GREENBELT STRUCTURAL SERVICES
A DIVISION OF TAHI LLC

TAHI Services and Greenbelt Structural performed a limited assessment at the above noted property. The purpose of the site visit was to assess the condition of the pool structure and surrounding outdoor features in order to collect additional information related to code and/or construction standard discrepancies identified in previous inspection reports.

POOL INSPECTION REPORT STATEMENTS AND FINDINGS

FIGURE #1

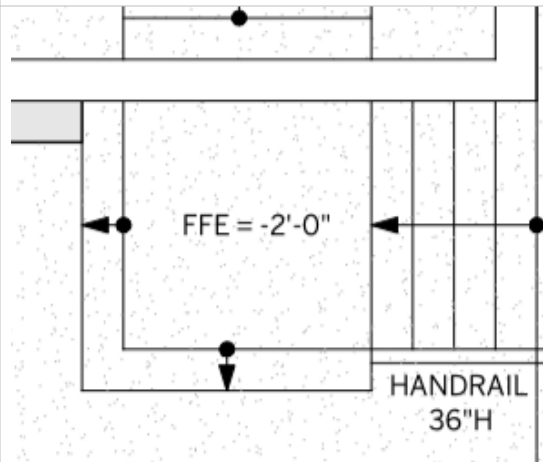
Deficient: Excess gap at stairs and retainment wall structure. All stairs risers and treads must be uniform. Notably, should the excess gap simply be tiled-over, this could create a significant safety hazard, as someone could fall through by breaking tile. Tile is a finish material and not a structural member.

In the first identified deficiency, the pool inspector notes an “excess gap at stairs and retainment wall structure”. The pool report does not cite specific code in regards to this issue, however, the statement does reference a need for uniformity. The need for stair uniformity is detailed in IRC 2015 R311.7.5.1. The code requirement states, in part, the following:

Based on our findings, we concur with the statement provided in the pool inspection report. The stair configuration, as it was discovered by the pool inspector, violated specific code (IRC 311) and various general installation standards which prohibit non-uniformity at stairways. Examples additional guidelines and standards which prohibit non-uniformity include, but are not limited to the following:

Review of photos provided in the pool inspection report are of note in that it appears the construction of the stairs was erroneous (as opposed to the issue being present due to incomplete construction). In the report photo (see Figure #1 below), it is apparent that the gap is located between the rough installed hand railing and stair tread. The concern associated with the construction method (as discovered during the pool inspection) is further noted on page 8 of the pool inspection report:

“Notably, should the excess gap simply be tiled-over, this could create a significant safety hazard, as someone could fall through by breaking tile. Tile is a finish material and not a structural member.”
